United States Patent and Trademark Office

PPLICATION NO.	FILING DATE	FIRST NAMED INVENTOR	ATTORNEY DOCKET NO.	CONFIRMATION NO
10/710,929	08/13/2004	Yihua Lu	MSCP0029USA	4928
27765	7590 07/22/2005		EXAMINER	
NORTH AMERICA INTERNATIONAL PATENT OFFICE (NAIPC)			VY, HUNG T	
P.O. BOX 50 MERRIFIEL	D, VA 22116		ART UNIT	PAPER NUMBER
	•		2821

DETAILED ACTION

Claims 1-2, 5-8 and 10-13 are rejected under 35 U. S. C. § 102 (e) as being anticipated by admitted prior art (Admission) in Fig. 1.

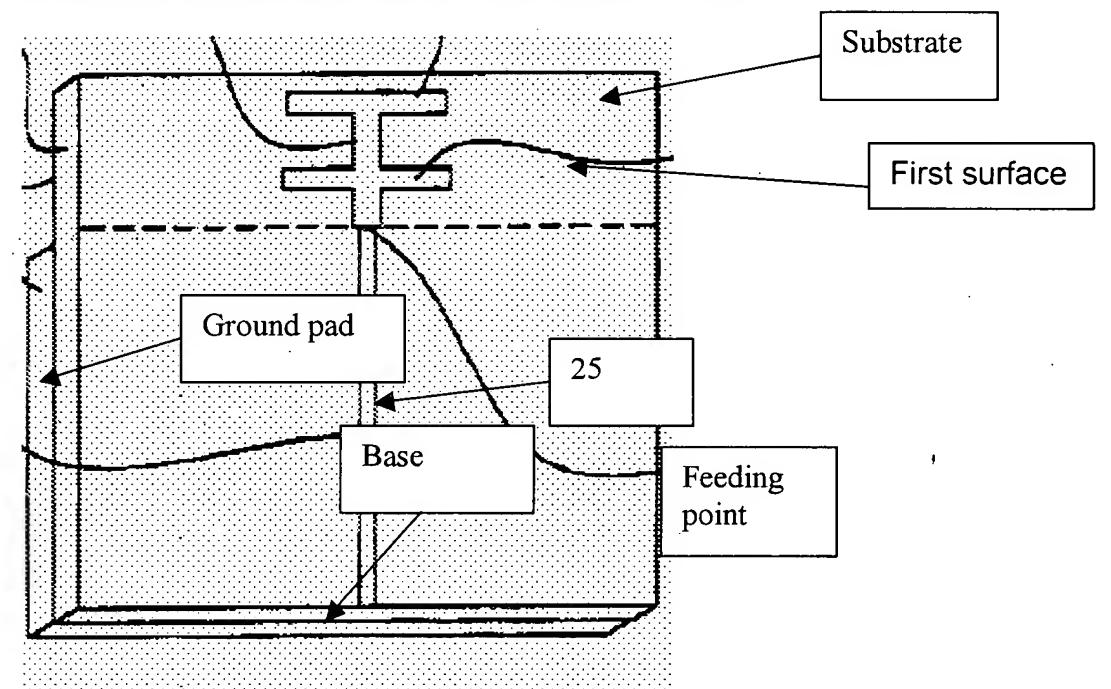
Claim 1, Admission discloses a dual-band antenna, comprising a substrate 24 having a first surface and a second surface that is on the opposite side of the substrate 24 from the first surface, a transmission line 25 coupled to a feeding point for transmitting RF signals, an emitting unit having a first wire 21 and a second wire 22 that are both disposed on the first surface and the first wire 21 and the second wire 22 are crossed at the feeding point (See fig. above); and a ground pad 28 disposed on the

second surface of the substrate 24 (see fig. above), wherein the ground pad 24 comprises a base from the base extending toward the feeding point (See fig. above).

Claim 2, Admission discloses a transmission is a microstrip 25 (See fig. above).

Claim 5, Admission discloses the base of the ground pad is substantially rectangular (see fig. above).

Claims 6-8, Admission discloses an extension 28 disposes on the second surface and extending from the base toward a first edge of the substrate (see fig. above), the extension is adjacent to the emitting unit and the extend of the ground pad is substantially rectangular in shape (See fig. above).

Claims 12-13. Admission disclose the second wire 22 is extended upward from the feeding point and bent at some angle, being parallel to on side of the base and the first wire parallel to one side of the base (See fig. 1)
